AUDIO SERVICE

BULLETIN NO.: 07-81

SUBJECT: CR-2020

ELECTROLYTIC CAP. C. BOARD

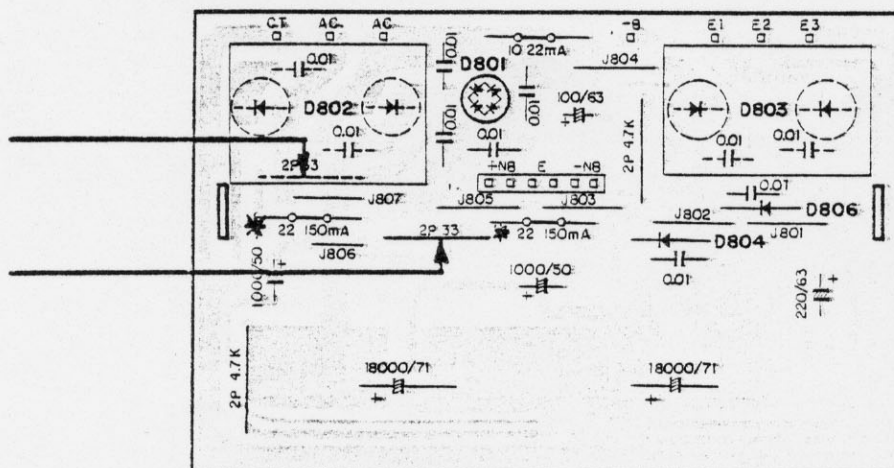
Problem: Intermittent power supply.
Receiver goes on and off, speaker relay clicking.

Cause: R 801 and R 802 (33 ohm) in electrolytic capacitor circuit board get hot and unsolder themselves.

Remedy: Remove both resistors and install new 33 ohm, 3 $\frac{1}{2}$ watt wire wound resistors.

Mount the resistors approximately $\frac{1}{4}$ inch away from the circuit board.

We suggest to use Ohmite #4374. These resistors are available from Yamaha Canada Music, Parts Department.

* Also replace the 22 ohm 150 mA fuse resistors with Ohmite #4369 22 ohm 3 $\frac{1}{2}$ watt resistors.

Location of resistors:
